BOARD OF COUNTY COMMISSIONERS
ORANGE COUNTY, FLORIDA
IFB NO. Y18-779-TA/ ADDENDUM NO. 4

NORTHWEST WATER RECLAMATION FACILITY RAPID INFILTRATION BASINS
(RIBS) SIDE SLOPE LINERS REPLACEMENT PROJECT

GENERAL RIB CELL CROSS SECTION

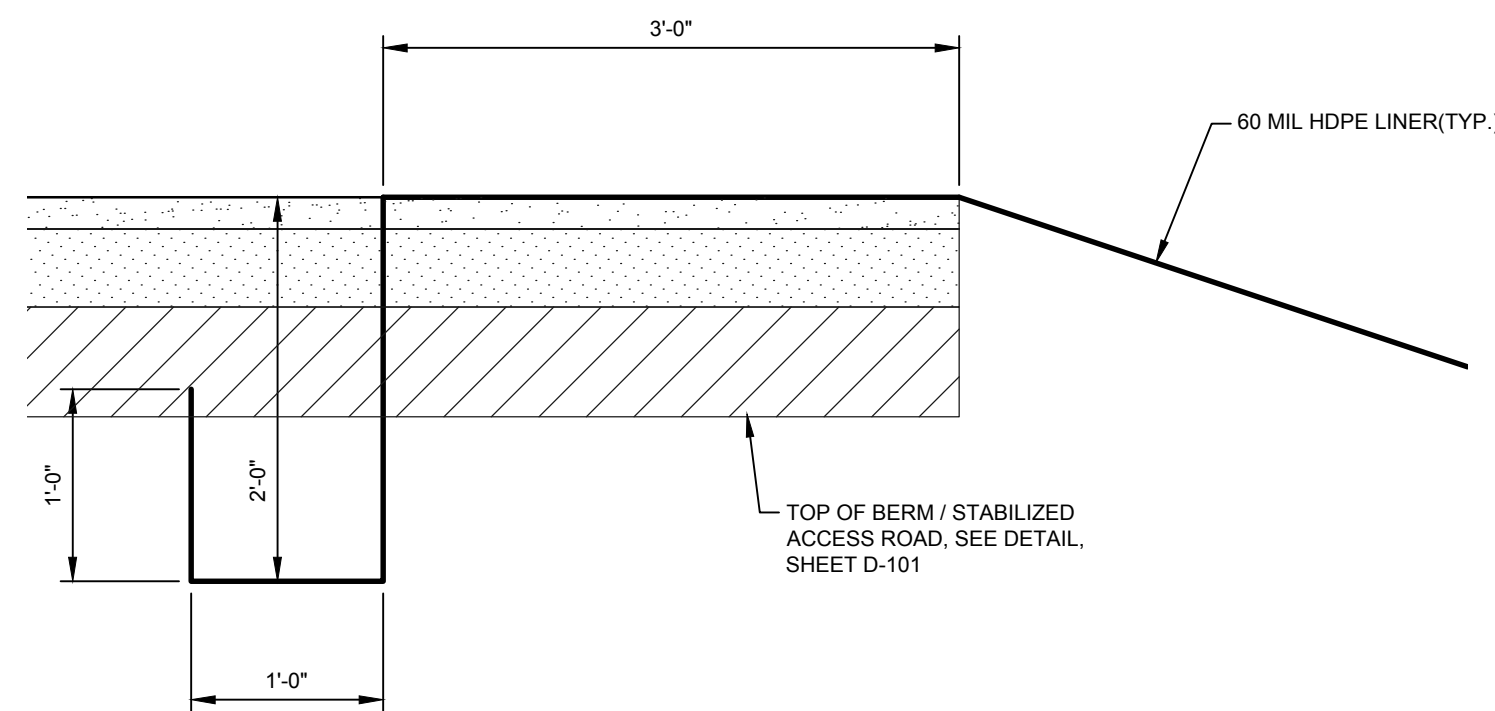
4. **Q:** The detail entitled “General RIB Cell Cross Section” on plan sheet D-100 shows the upslope anchor trench of the liner dug into the stabilized access road. Is that the intent of the design?

- A: It is shown three (3) feet into the top of berm, not necessarily into a stabilized access road.
5. **Q:** The “General RIB Cell Cross Section” detail on plan sheet D-10 also shows a “Limit of sod” width without any dimensions. It appears that the sod should carry down the outside slope of the pond berm and upslope from the tie-in to existing grade. There is no way, however to quantify the amount of sod required based on the information provided in this detail. Are we to regrade the entire outside pond berm? If so, how far past the toe of slope should we plan to re-sod after the regrading is complete?

- A: Sodding shall extend only to areas disturbed during construction. This will vary for each pond depending on construction activity, equipment, etc. The outside of the ponds are not intended to be regraded or sodded unless disturbed.

HDPE LINER DETAIL

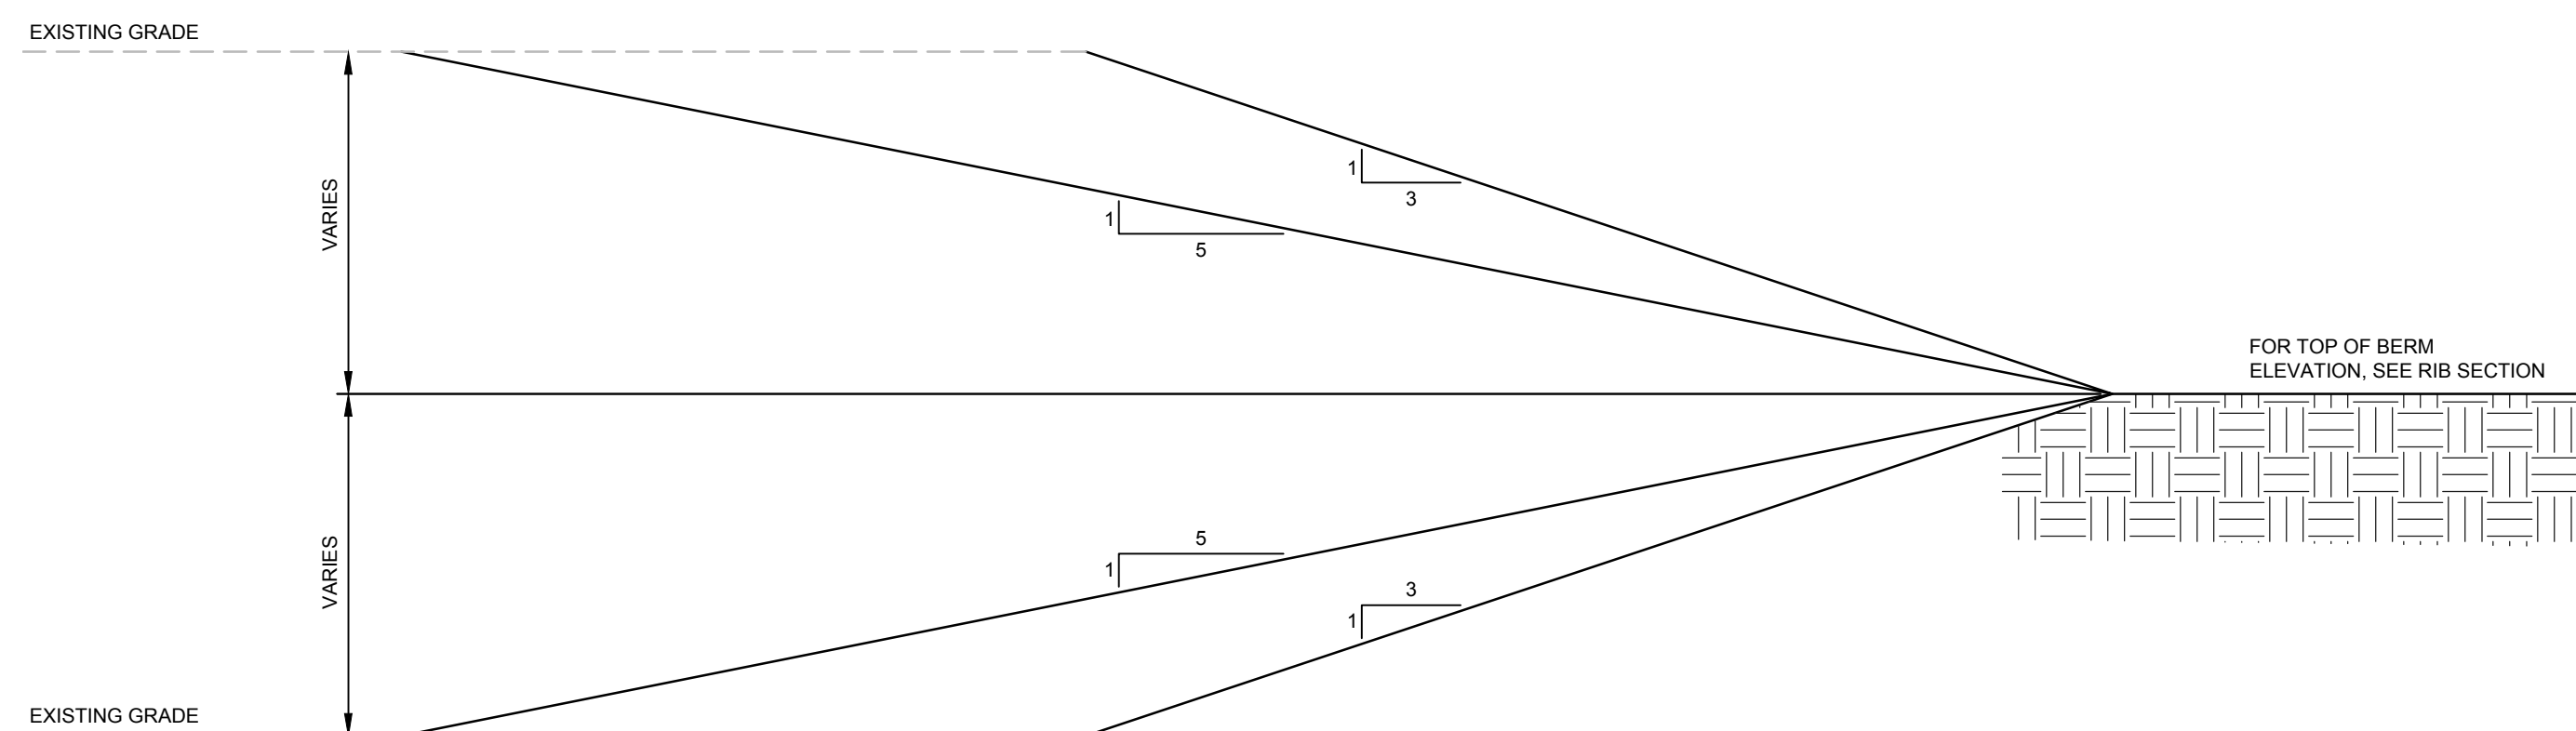
12. **Q: The “HDPE Liner Detail” on plan sheet D-100 shows a 4” x 5’ Schedule 80 PVC edge of liner marker at the edge of the lower anchor trench. What should the spacing be between these markers?**

- A: The spacing should be approximately 100 feet.
13. **Q: Since the project consists of 15 RIBs that can easily be rebuilt in the timeframe allotted, will it be necessary to provide and maintain a CPM schedule for this contract? It appears that a more simplified bar chart Microsoft Project type of schedule would suffice.**

HDPE LINER TO CONCRETE TIE DETAIL

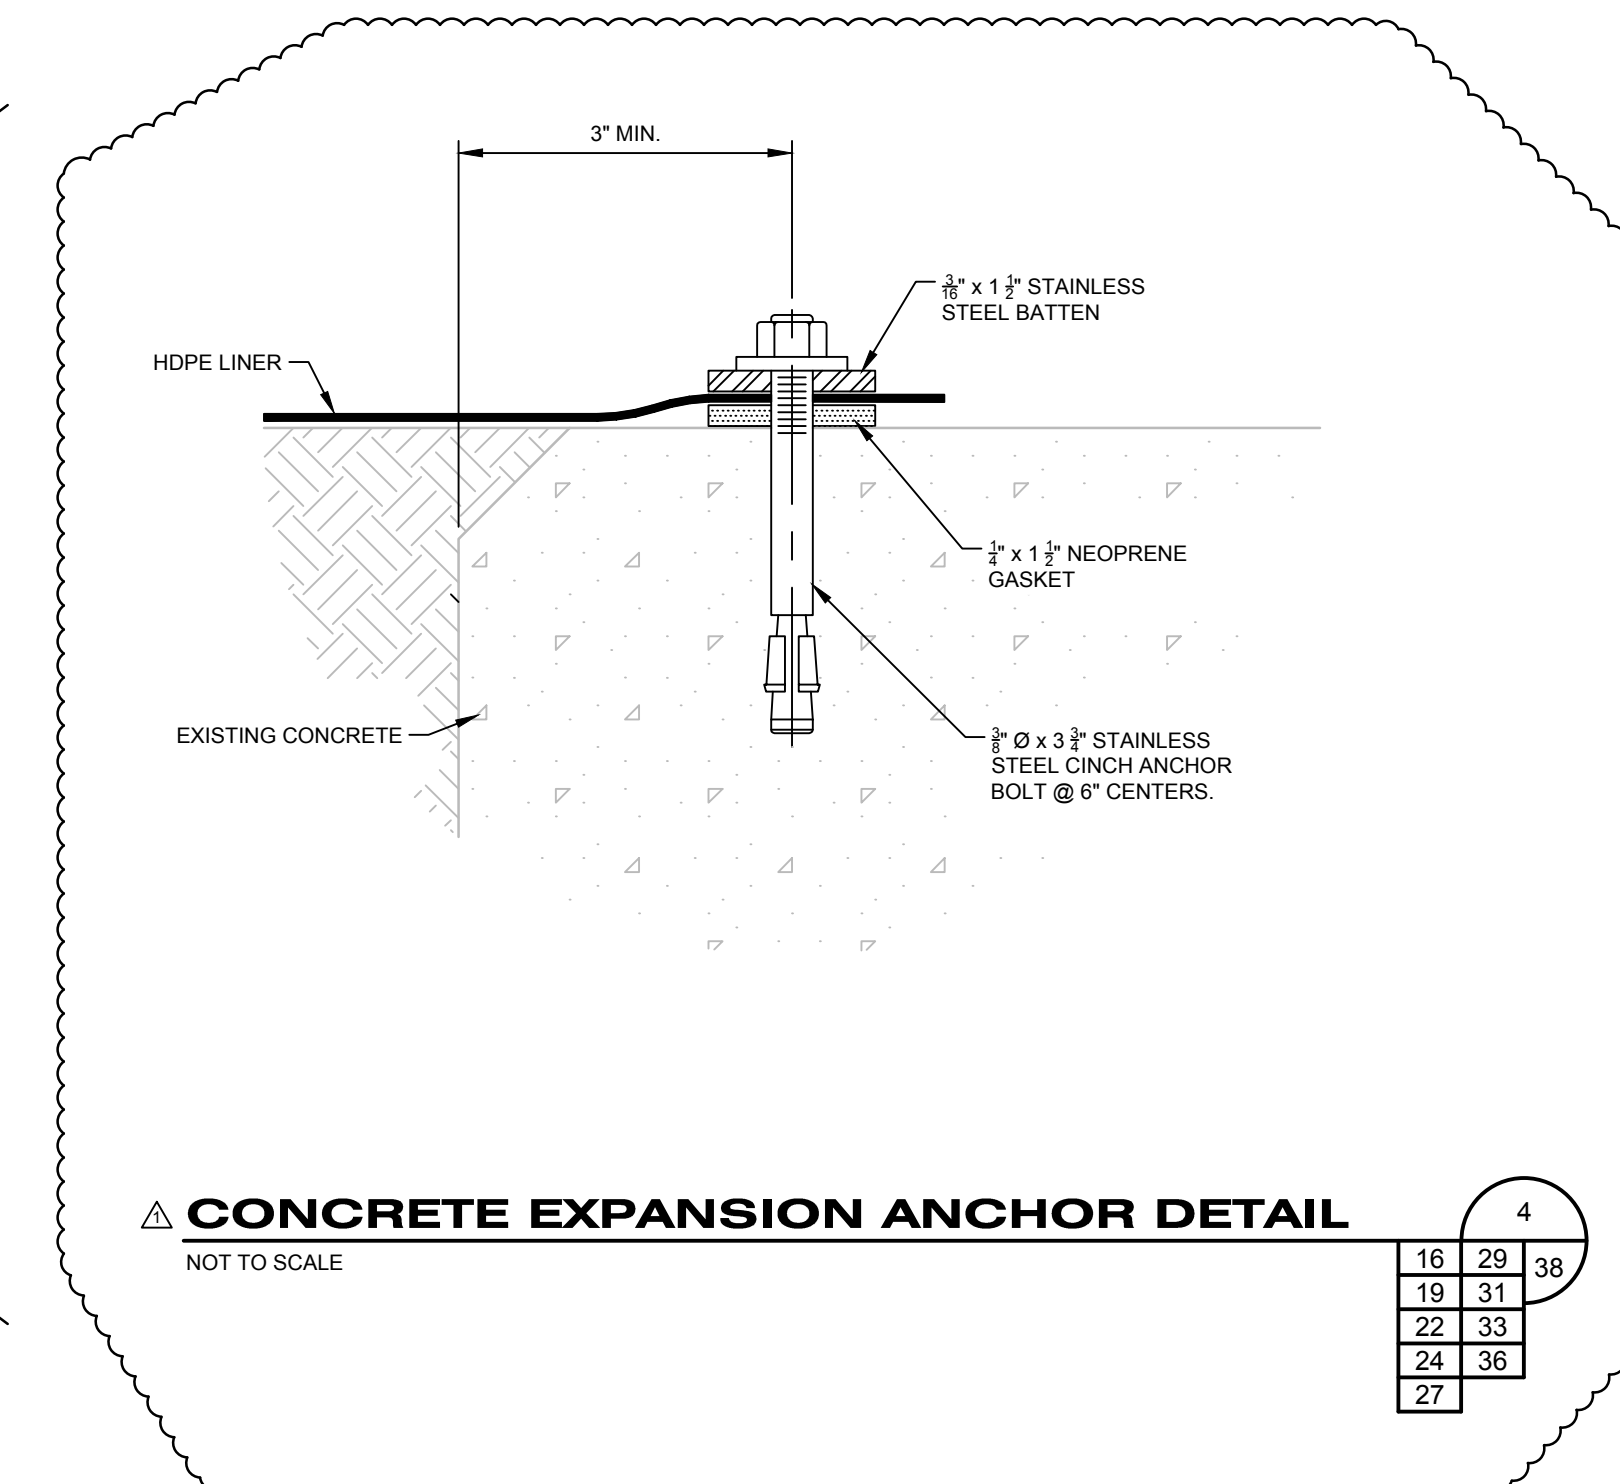
6. **Q:** The detail entitled “HDPE Liner to Concrete Tie Detail” on plan sheet D-100 shows a typical “Polylock” concrete embed stip. Note #1 on this detail states to “remove existing liner and install new anchor system in concrete drives and overflow channels.” Does this mean that the Polylock is to remain and that we are to cut the old liner away and weld the new liner to it?

7. **Q:** For the Polylock detail, is it correct to assume that the Polylock exists at all drives and overflows? As there is no way to embed Polylock into existing structures, installing batten bar would be the only way to install a new anchor system in the drives and channels. If that is the intent, please provide batten bar details, specs, and quantities.

- A: The polylock detail has been removed. Liners shall be anchored in concrete drives and overflow channels. A batten bar detail has been added to revised Sheet D-100. This detail will be used at all liner connections at all concrete crossings and will extend along the length of liner contacting concrete surfaces. Refer to revised sheet D-100 attached and labelled this addendum.

- A: A detail has been added as noted in response 6.

△ LINER VENT DETAIL
NOT TO SCALE

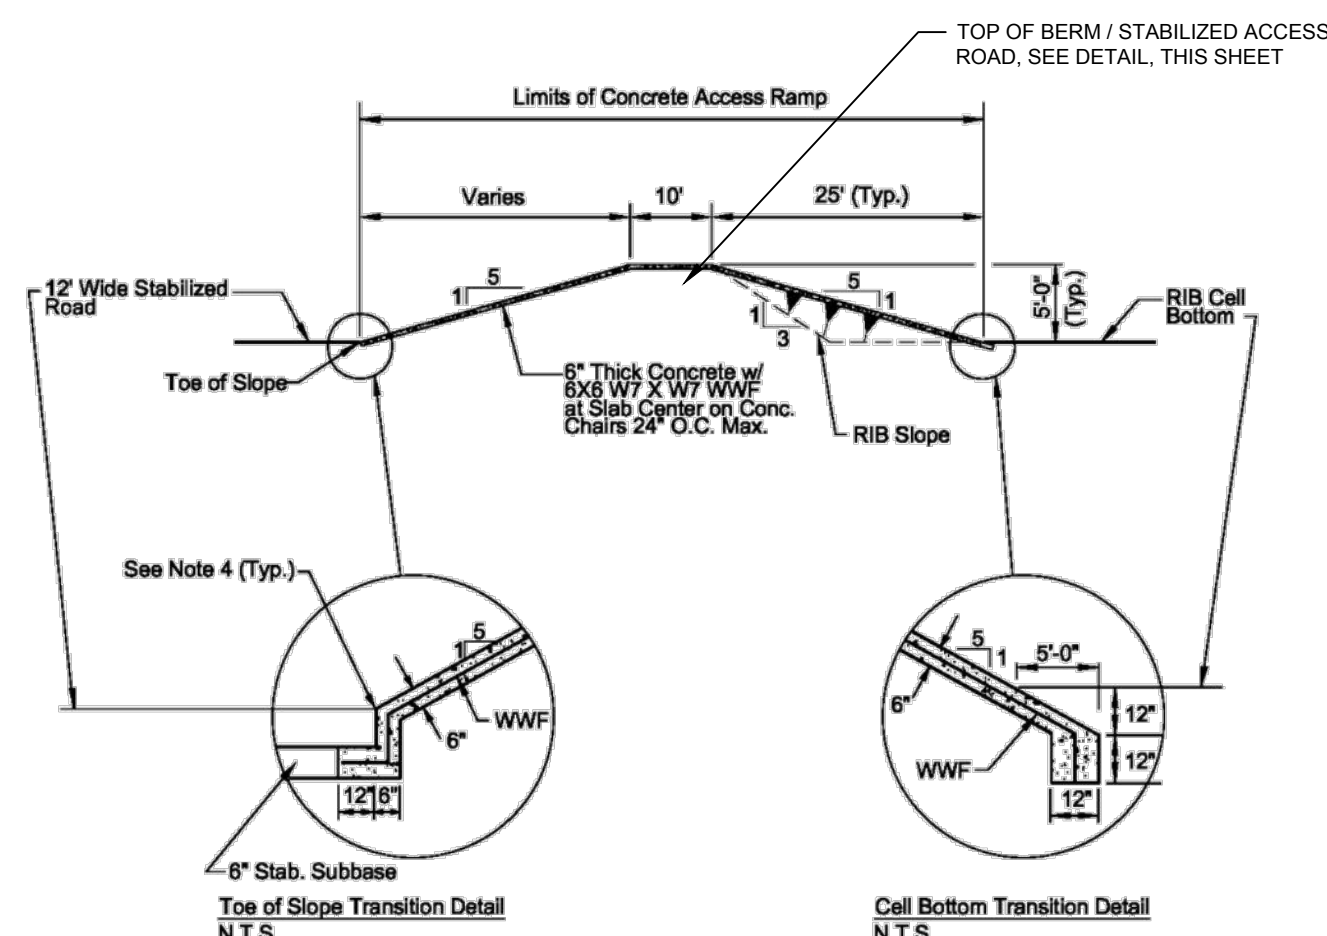
- 18. Q: What will be the frequency of the liner vents on the slopes of the RIBs?**
- A: Vents shall be installed every 50 feet.
- 19. Q: Please provide a detail for the liner vents.**

- A: A detail for the liner vents has been provided on revised sheet D-101 attached and labelled this addendum.
- 20. Q: Is there a designated area onsite available for use as a materials storage/laydown area?**

△ TOP OF BERM / STABILIZED ACCESS ROAD DETAIL

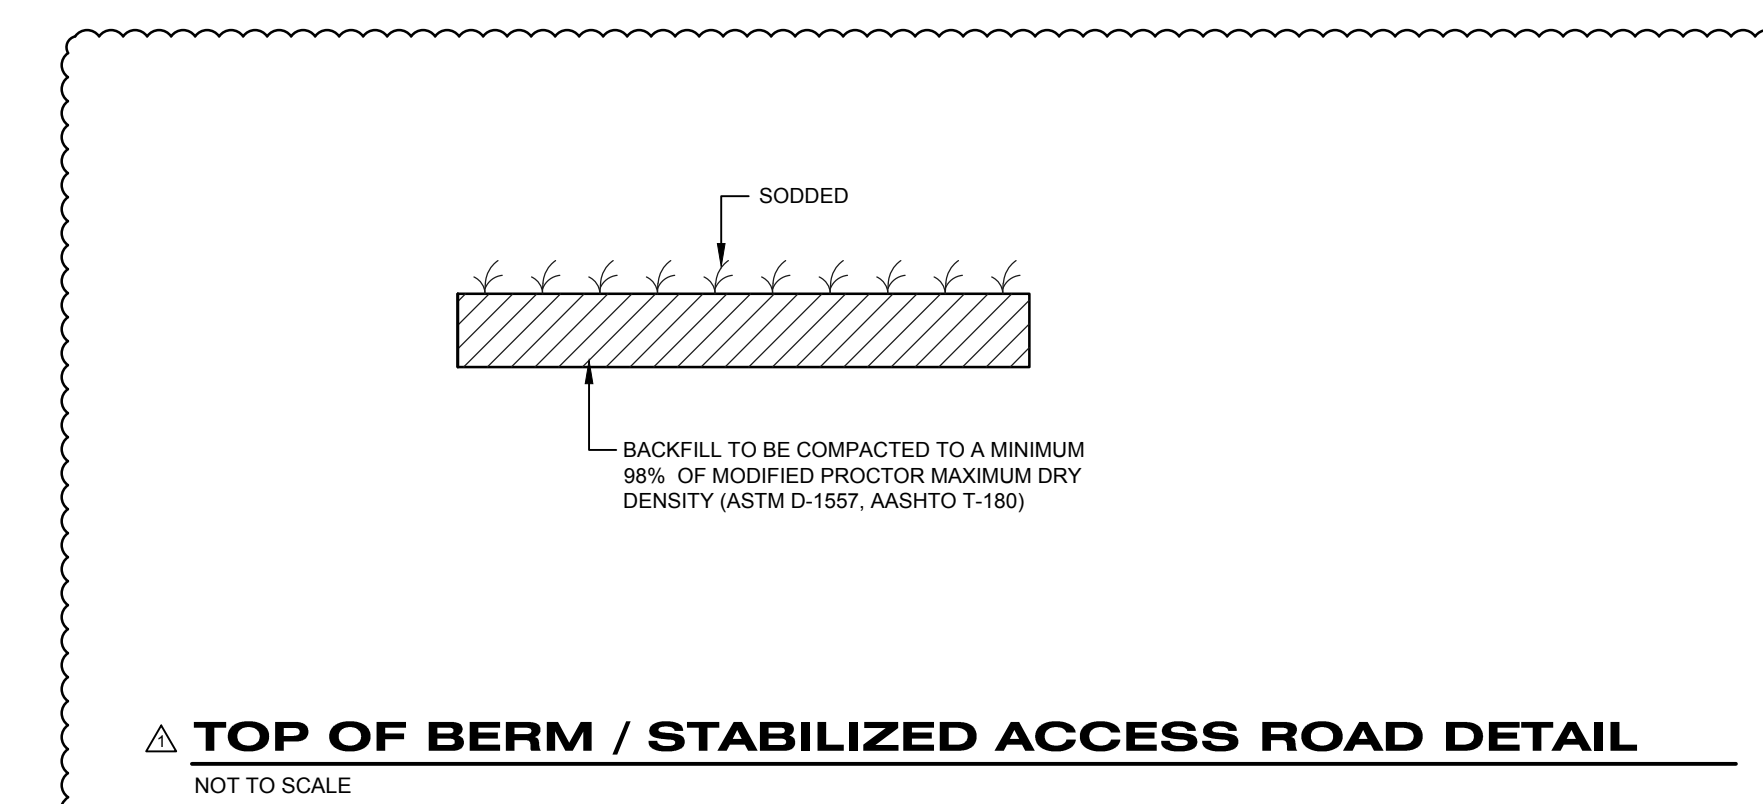
8. **Q: The detail entitled “Top of Berm/Stabilized Access Road Detail” on plan sheet D-101 illustrates a road profile. Does this detail depict existing conditions at the site?**

9. **Q: Will the “Stabilized Access Road” be constructed around all of the RIBs?**
- A: No new roads are to be constructed. Only disturbed areas on top of berms are to be restored in accordance with the revised detail on sheet D-101.

10. **Q: The detail shows a 10’ minimum width for the top of berm. Are all of the existing berm tops a minimum of 10’ wide?**
- A: Not all top of berms are 10 feet wide and vary up to 15. The Work does not include widening the existing berms but only the restoration of areas disturbed for liner installation.

11. **Q: Is topsoil available onsite for the 4” layer that is to be placed on top of the berm/stabilized access road?**
- A: Per the revised detail on sheet D-101, the 4” layer has been removed with sod being installed on the compacted soil. However, contractors must provide adequate soils with the sodding to assure the sod will take root.

- A: The detail has been revised to show conditions based on the original design. Please see revised drawing on sheet D-101 attached and labelled this addendum. The stabilization requirement has been removed.
